Serial No. 10/797,645

Amendments to the Drawings:

REMARKS/ARGUMENTS

Fig.3

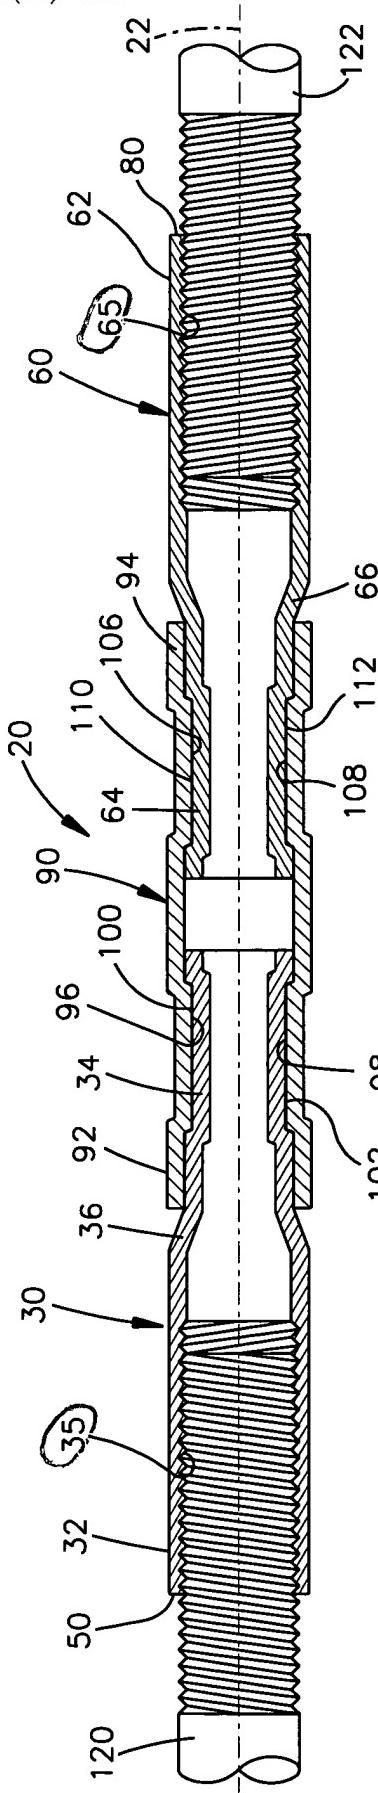
The attached sheet from the drawings includes changes to Figs. 3-5. The sheet replaces the original sheet including Figs. 3-5. In Figs. 3-5, reference character "35" is designated as the threaded portion of the first sleeve 30, and reference character "65" is designated as the threaded portion of the second sleeve 60. Fig. 5 is corrected to show the longitudinally extending seam 44. No new matter is added in these amendments to the drawings.

The drawings are corrected to designate reference character "35" as the threaded portion of the first sleeve 30, and reference character "65" as the threaded portion of the second sleeve 60. Figure 5 of the drawings is corrected to show the longitudinally extending seam 44. An annotated drawing sheet is provided that shows these changes marked in red. No new matter is added in the drawings by these changes. Therefore, the objection to the drawings should be withdrawn.
